-001 BRACKET

-001	BRACKET	1.5 x 1.6 x 2.0	304 QQ-S-763 Ⓐ	
		PART NO.	NAME	STOCK SIZE	MATERIAL	ZONE
NO. REQ'D PER ASSY		LIST OF MATERIAL				
PROPRIETARY RIGHTS NOTICE		UNLESS OTHERWISE SPECIFIED		DFTSMAN	D. NELSON	2/14/03
THESE DATA ARE PROPRIETARY TO ERA AVIATION, INC. DISCLOSURE, REPRODUCTION, OR USE OF THESE DATA FOR ANY PURPOSE IS FORBIDDEN WITHOUT WRITTEN AUTHORIZATION FROM ERA AVIATION, INC. THE FOREGOING DOES NOT APPLY TO VENDOR PARTS.		X.±.1		CHECK	D. MURPHY	2/14/03
		XX.±.03		STRESS		
		XXX.±.010		PROL. ENGR.		
		ANGLES ±.1/2°		HEAT TREAT		
-001 2 41232-000-001		NEXT ASSEMBLY		FINISH	⚠	
DWN NO.		REQ'D FOR ASSY		DWG. NO. C SCALE 2:1		
				DWG. NO. REV. A		
				Era Aviation, Inc. 41232-200-006

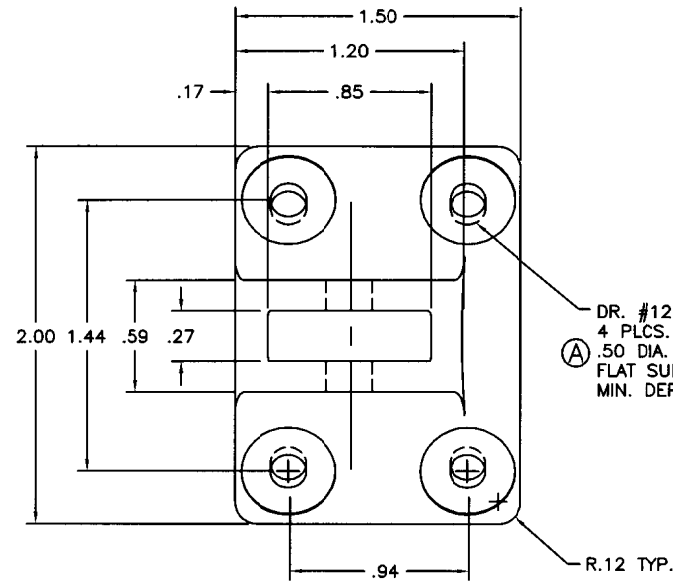
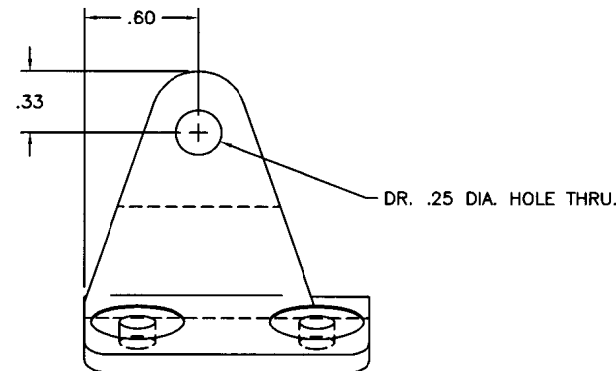
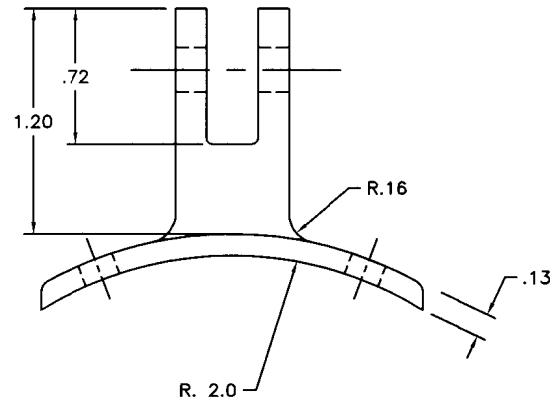
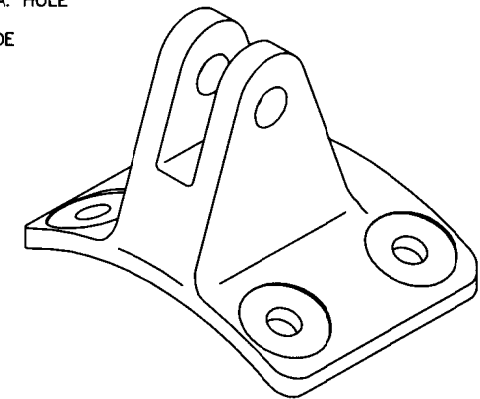
REVISION					
LETTER	DFTSMAN	DATE	DESCRIPTION	APPROVED	DATE
A	DNN	3/12/03	INCREASED DIMENSIONS OF HOLE & SPOTFACE; ADDED NOTE 1 & MAT'L SPEC; ADDED RADIUS DIM. TO CORNERS. MINOR CHANGE - FAR 21.95

⚠ QQ-P-35 PASSIVATE FINISH. Ⓐ
